# Proposed Solar Farm on Land South of Potterne Park Farm

## LVA Review

- 1.1 This report comprises a review of the landscape and visual appraisal (LVA, Tir Collective, December 2023) for the development of a solar farm on land south of Potterne Park farm, Potterne (ref PL/2023/10332). It has been commissioned by the Potterne Solar Action Group, in support of their consultation response, and has been prepared by Peter Radmall, MA Geography, B.Phil Landscape Design, CMLI.

**Figure 1: Proposed Layout**

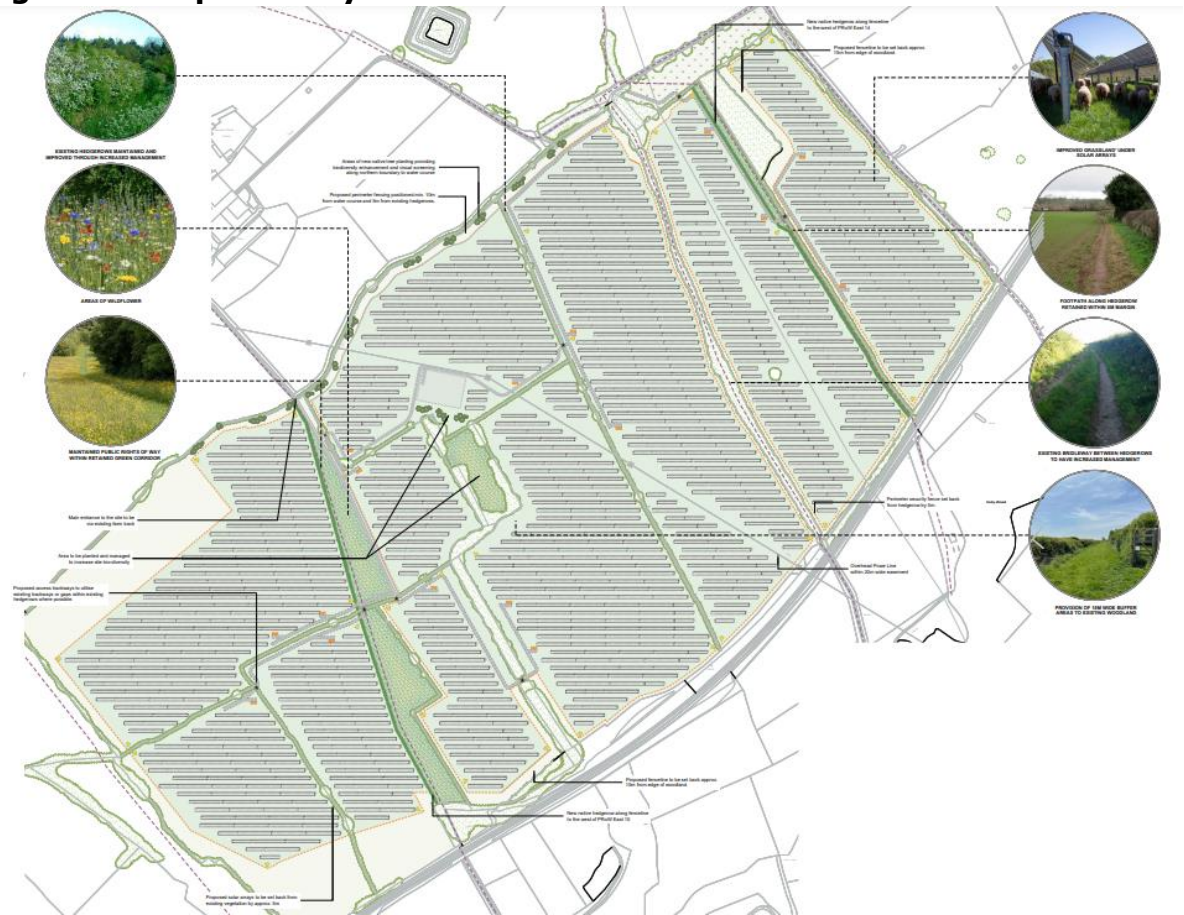
- 4.9 The LVA provides a somewhat cursory description of the development and its sources of impact (barely two pages). The proposed layout is not shown – for example, in relation to the PRoWs and assessment viewpoints. By way of rectification, the layout is presented in **Figure 1** below. Only one illustration of what is assumed to be a comparable example of an operational solar farm is provided (as a small inset on the Proposed Site Block Plan). Montages or wireframes have not been prepared for any of the views.

- 4.10 It is therefore very difficult to envisage the precise impact on each view, in terms of the extent of the solar arrays – which would occupy the majority (c72%) of the site – and the degree to which they may be visible or even obstruct some (usually close-range) views. As a result, it is equally difficult to judge whether the magnitudes of change identified in the LVA are reasonable (see also below).
